757

Service Bulletin

Number: 757-53A0103

SUBJECT: FUSELAGE - Section 43 and Section 46 - Structure - Inspection and Modification of
Open Holes on Frame Webs Between Stringers S-20 and S-25

FIGURE 1: OPEN HOLE HIGH FREQUENCY EDDY CURRENT INSPECTIONS BETWEEN STRINGERS S-20 AND S-25 FROM STA 440 TO STA 820 AND FROM STA 1300 TO STA 1701 (SHEET 1 OF 4)

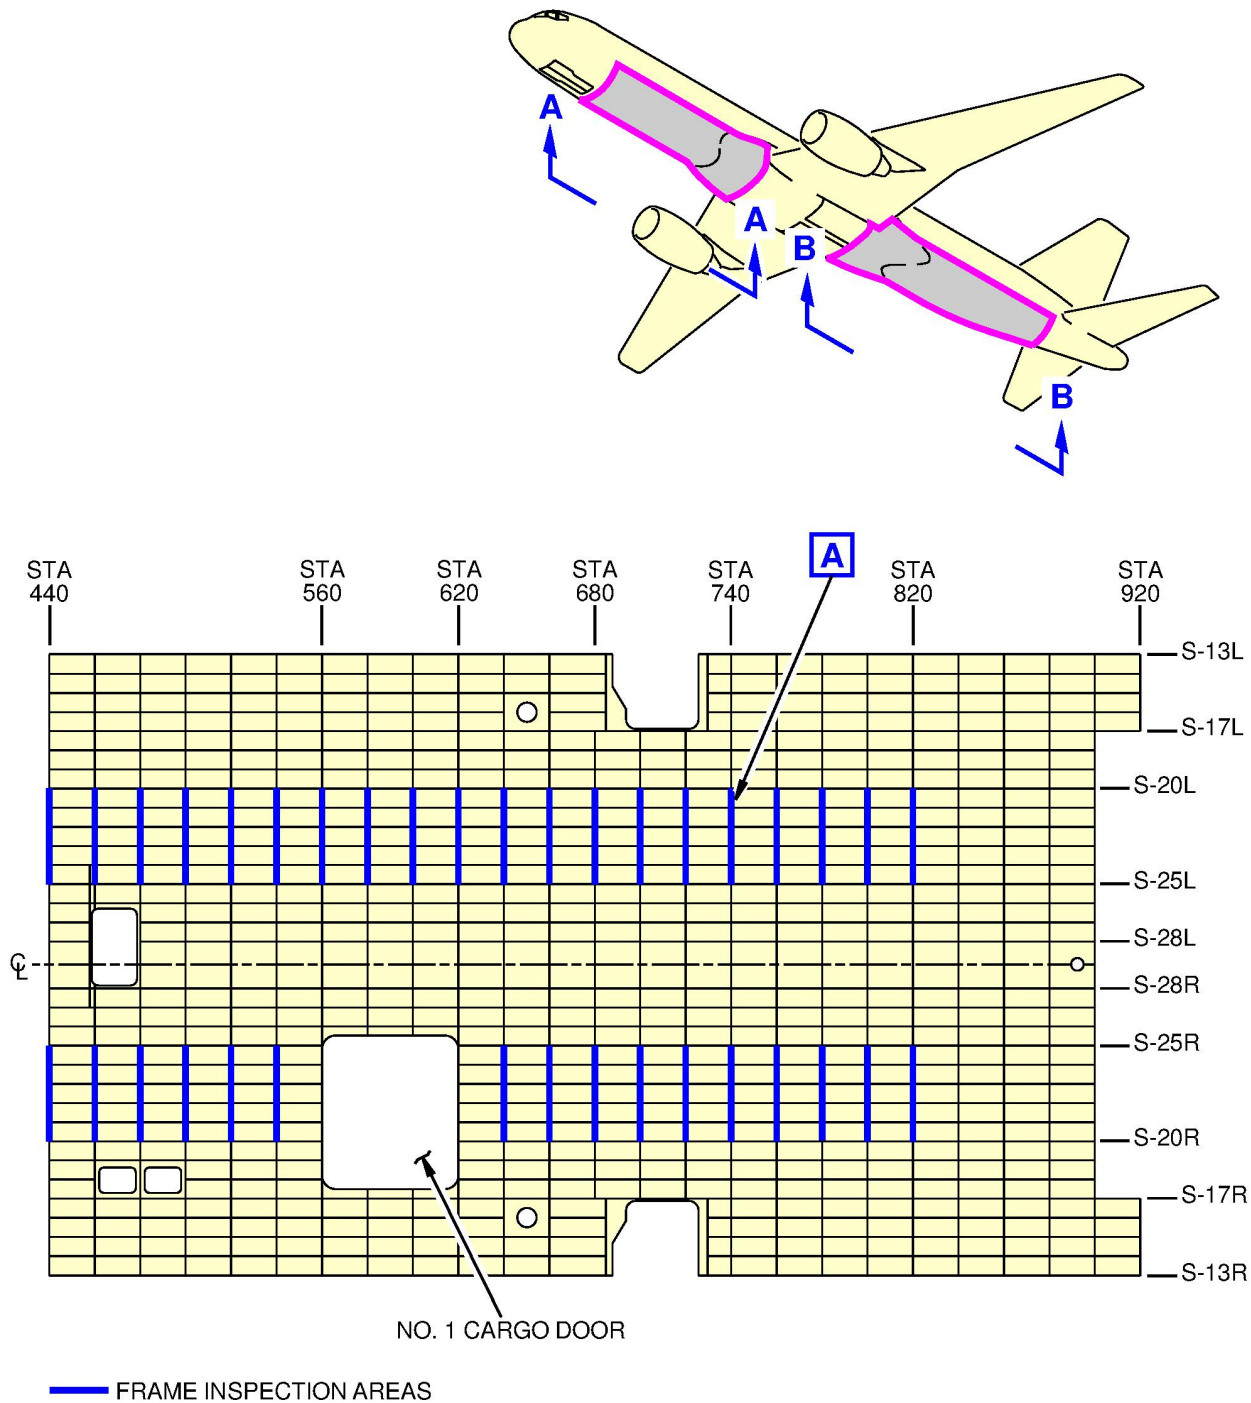
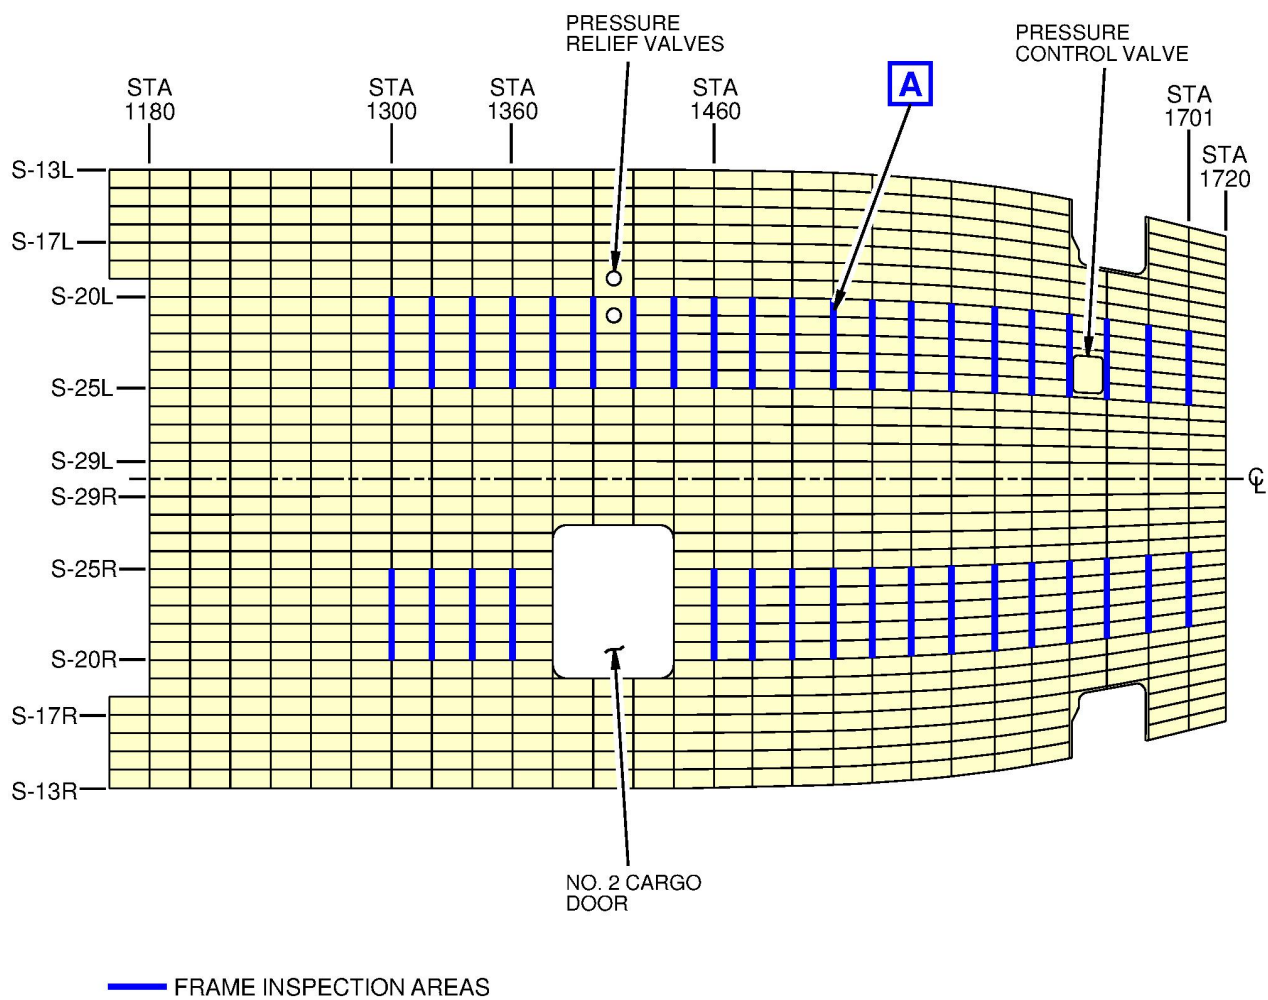
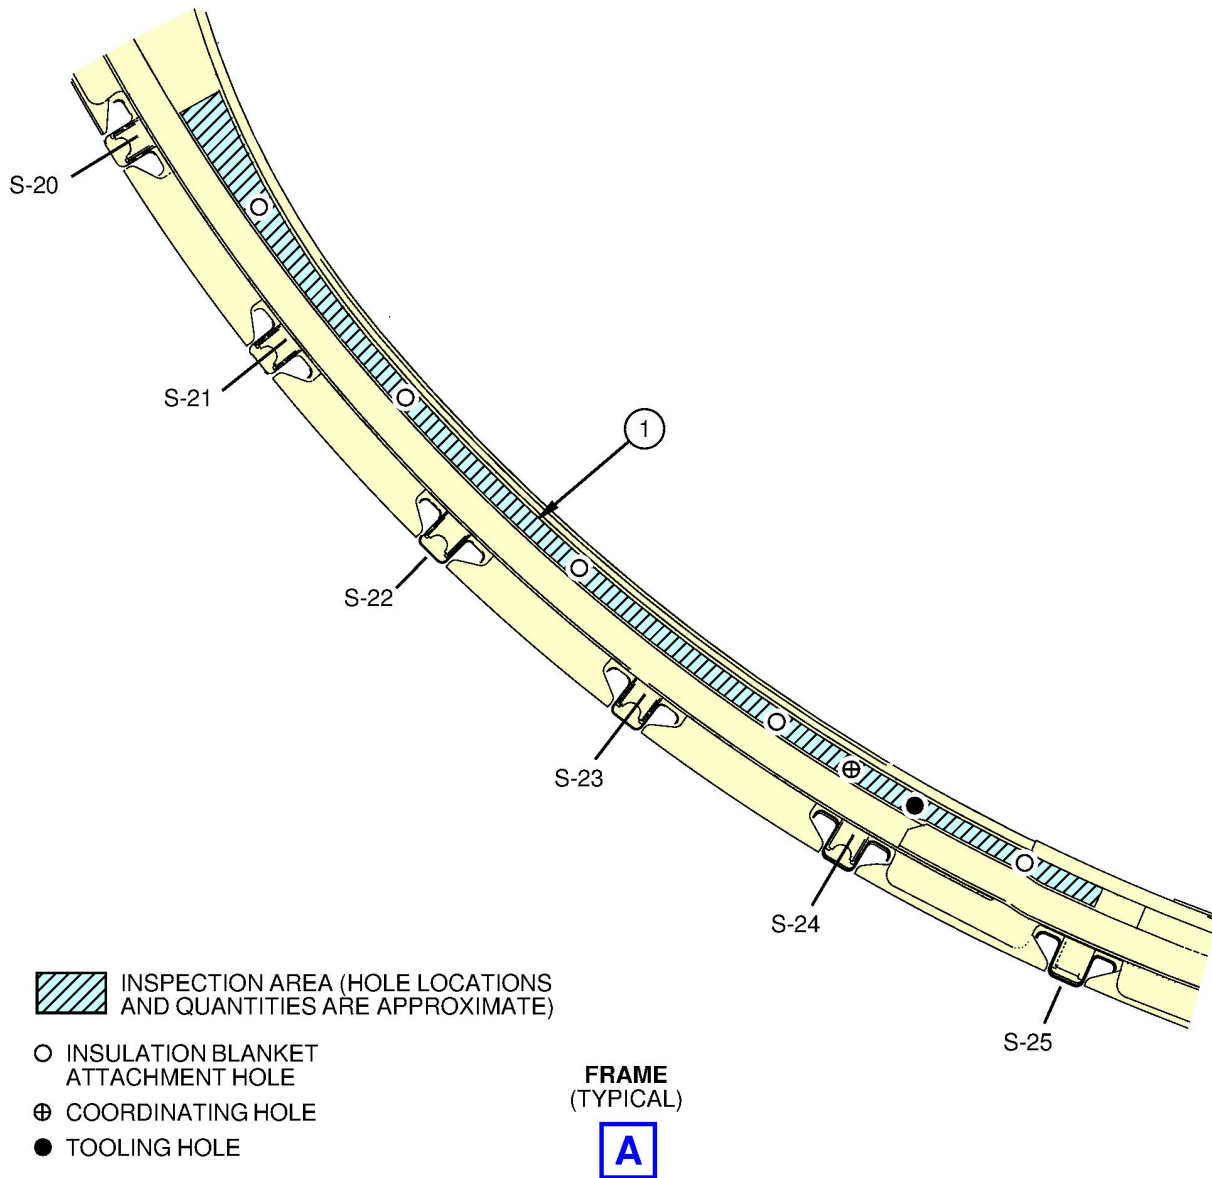
Inspect the frame webs for any open coordinating holes, tooling holes, and insulation blanket holes between S-20 and S-25 on the left side from STA 440 to STA 820 and from STA 1300 to STA 1701; and on the right side from STA 440 to STA 540, from STA 640 to STA 820, from STA 1300 to STA 1360, and from STA 1460 to STA 1701. Do an open hole high frequency eddy current inspection (HFEC) for any crack in the open coordinating holes, tooling holes, and insulation attachment blanket holes in accordance with FIGURE 1.

Step	Task	Name	Identification	Qty	More Data
1	Inspect	FRAME WEB	S-20L TO S-25L, STA 440 TO STA 820	20	(a) (b)
	Inspect	FRAME WEB	S-20R TO S-25R, STA 440 TO STA 540	6	(a) (b)
	Inspect	FRAME WEB	S-20R TO S-25R, STA 640 TO STA 820	10	(a) (b)
	Inspect	FRAME WEB	S-20L TO S-25L, STA 1300 TO STA 1701	21	(a) (b)
	Inspect	FRAME WEB	S-20R TO S-25R, STA 1300 TO STA 1360	4	(a) (b)
	Inspect	FRAME WEB	S-20R TO S-25R, STA 1460 TO STA 1701	13	(a) (b)

(a) In the inspection area, inspect for any open coordinating holes, tooling holes, and insulation blanket attachment holes. A typical coordinating hole has 0.278 - 0.291 inch diameter. A typical tooling hole has a 0.247 - 0.260 inch diameter. A typical insulation blanket attachment hole has a 0.154 - 0.166 inch diameter or 0.180 - 0.192 inch diameter.

(b) Do an open hole high frequency eddy current (HFEC) inspection of all open coordinating holes, tooling holes and insulation blanket attachment holes for any crack in accordance with 757 NDT Manual Part 6, 51-00-16.

FIGURE 2: OPEN HOLE HIGH FREQUENCY EDDY CURRENT INSPECTIONS BETWEEN STRINGERS S-20 AND S-25 FROM STA 440 TO STA 820 AND FROM STA 1300 TO STA 1701 (SHEET 1 OF 4)

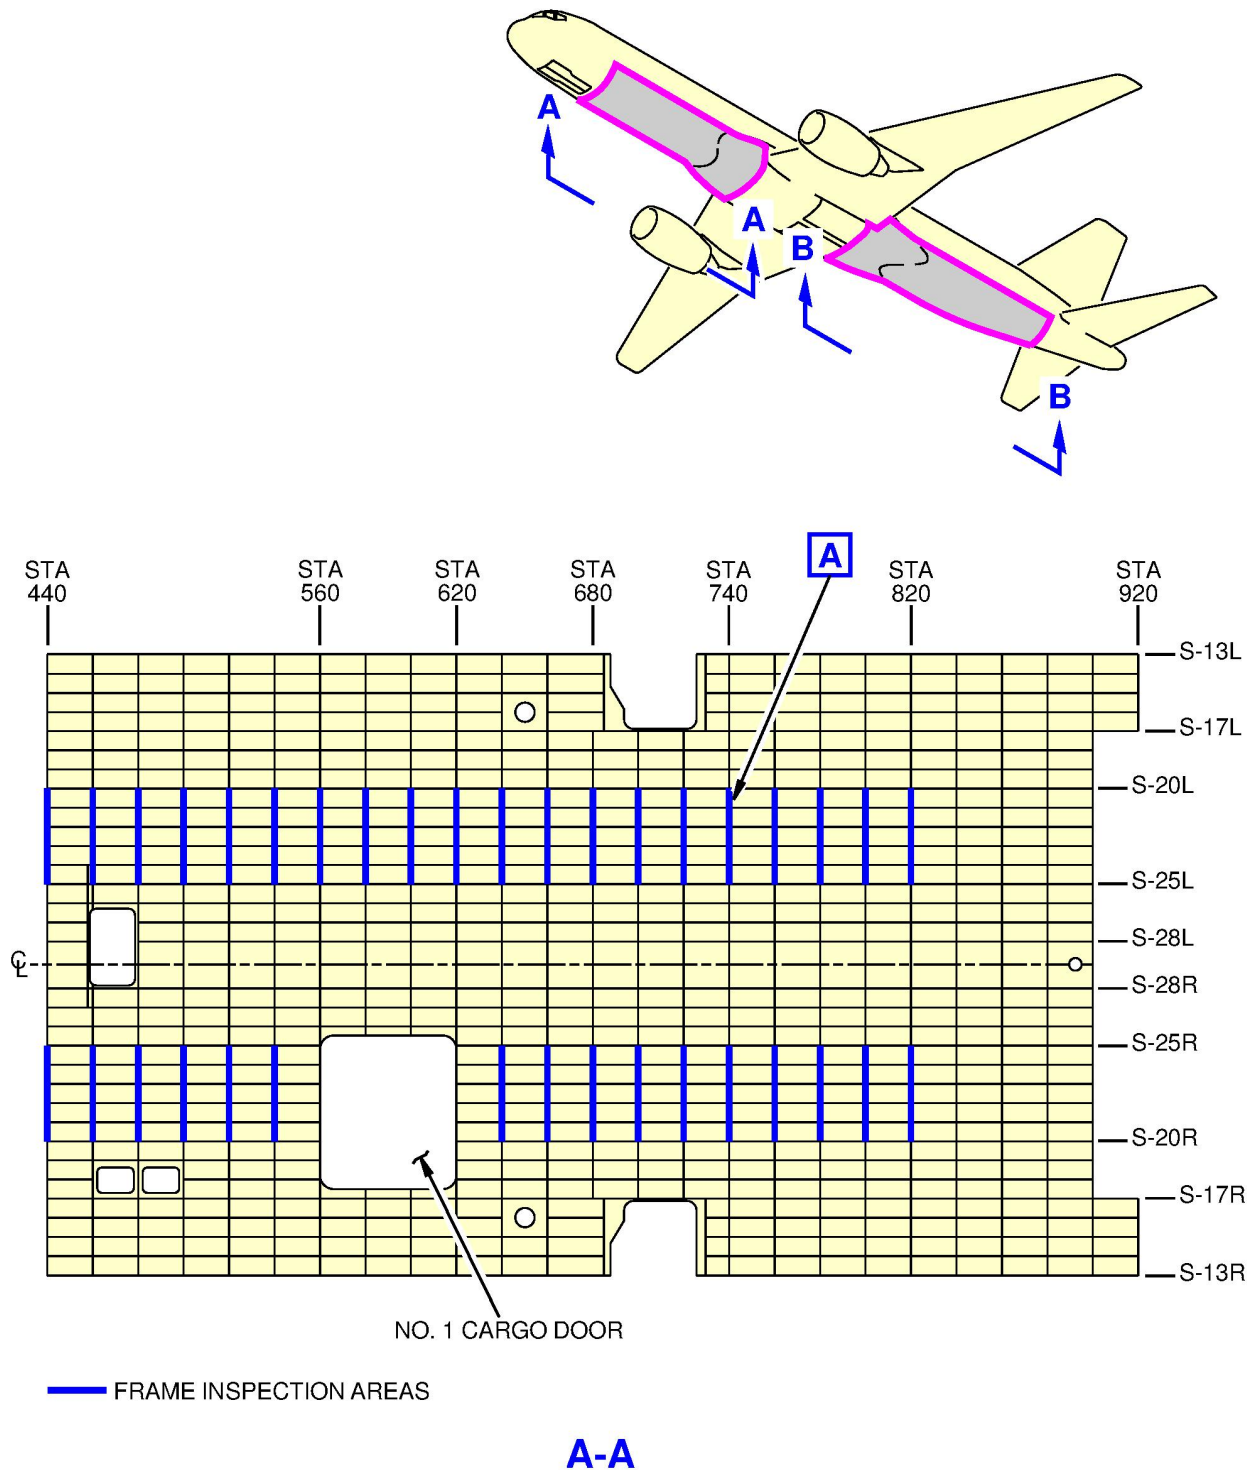
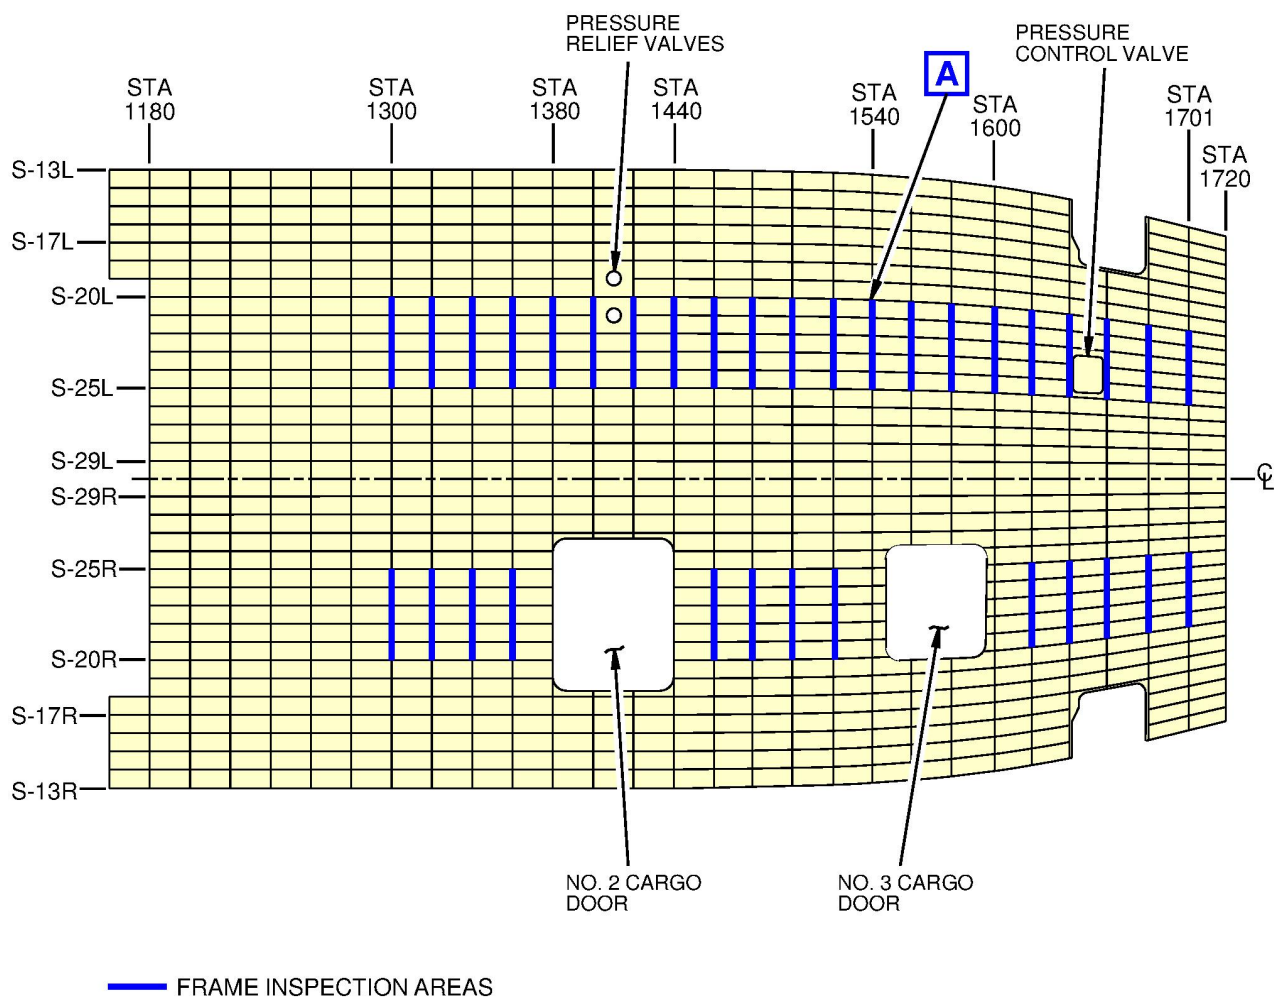
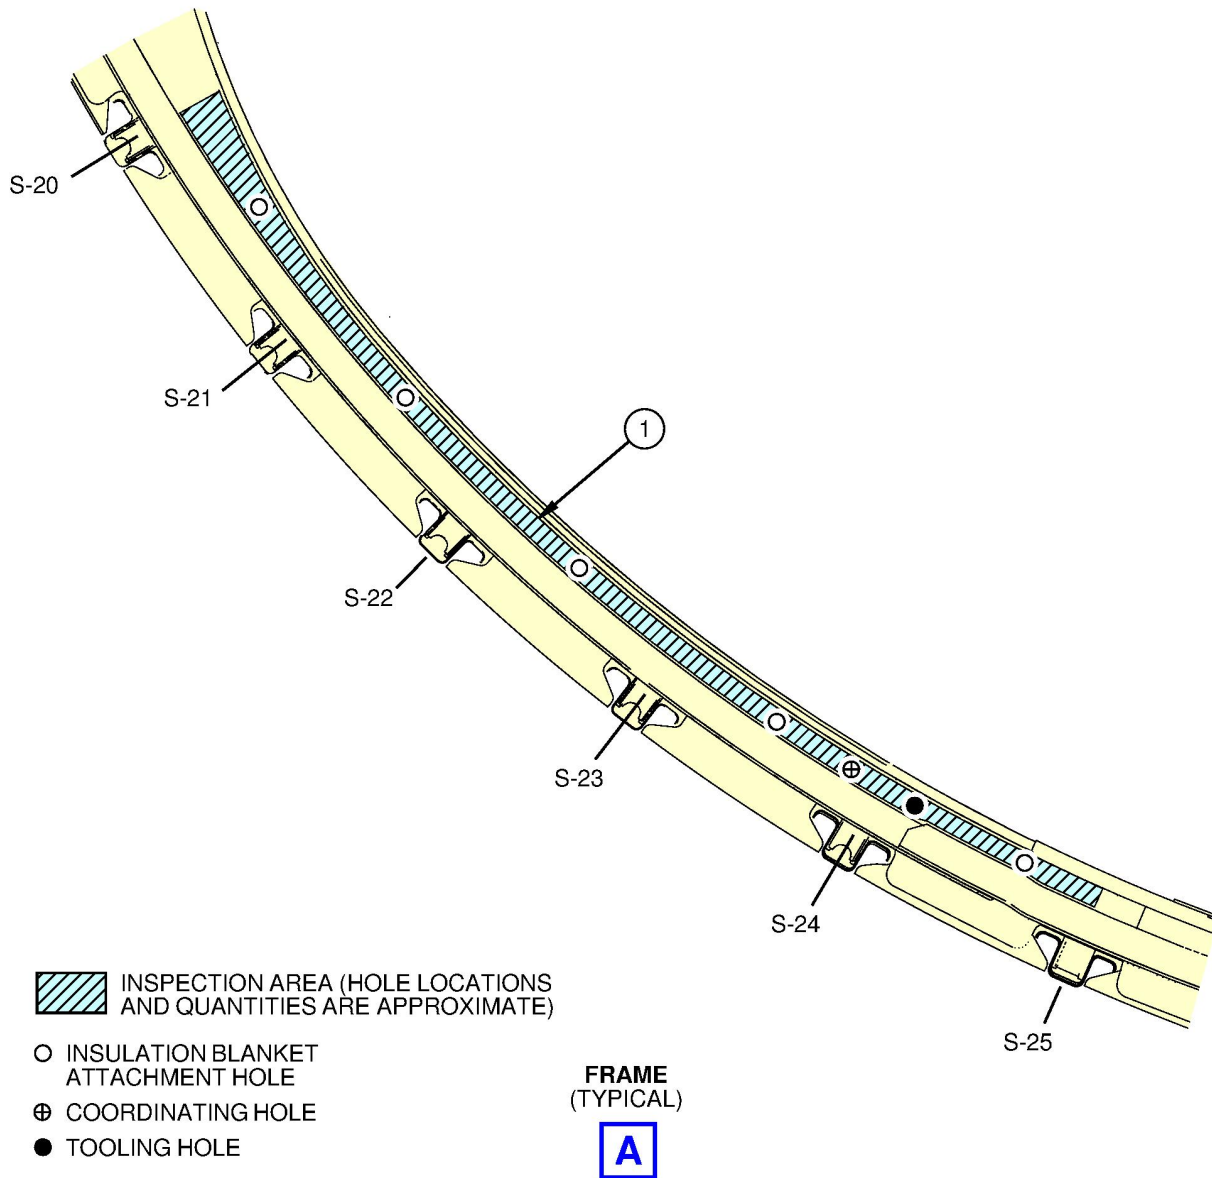
Inspect the frame webs for any open coordinating holes, tooling holes, and insulation blanket holes between S-20 and S-25 on the left side from STA 440 to STA 820 and from STA 1300 to STA 1701; and on the right side from STA 440 to STA 540, from STA 640 to STA 820, from STA 1300 to STA 1360, from STA 1460 to STA 1520, and from STA 1620 to STA 1701. Do an open hole high frequency eddy current inspection (HFEC) for any crack in the open coordinating holes, tooling holes, and insulation attachment blanket holes in accordance with FIGURE 2.

Step	Task	Name	Identification	Qty	More Data
1	Inspect	FRAME WEB	S-20L TO S-25L, STA 440 TO STA 820	20	(a) (b)
	Inspect	FRAME WEB	S-20R TO S-25R, STA 440 TO STA 540	6	(a) (b)
	Inspect	FRAME WEB	S-20R TO S-25R, STA 640 TO STA 820	10	(a) (b)
	Inspect	FRAME WEB	S-20L TO S-25L, STA 1300 TO STA 1701	21	(a) (b)
	Inspect	FRAME WEB	S-20R TO S-25R, STA 1300 TO STA 1360	4	(a) (b)
	Inspect	FRAME WEB	S-20R TO S-25R, STA 1460 TO STA 1520	4	(a) (b)
	Inspect	FRAME WEB	S-20R TO S-25R, STA 1620 TO STA 1701	5	(a) (b)

(a) In the inspection area, inspect for any open coordinating holes, tooling holes, and insulation blanket attachment holes. A typical coordinating hole has 0.278 - 0.291 inch diameter. A typical tooling hole has a 0.247 - 0.260 inch diameter. A typical insulation blanket attachment hole has a 0.154 - 0.166 inch diameter or 0.180 - 0.192 inch diameter.

(b) Do an open hole high frequency eddy current (HFEC) inspection of all open coordinating holes, tooling holes and insulation blanket attachment holes for any crack in accordance with 757 NDT Manual Part 6, 51-00-16.
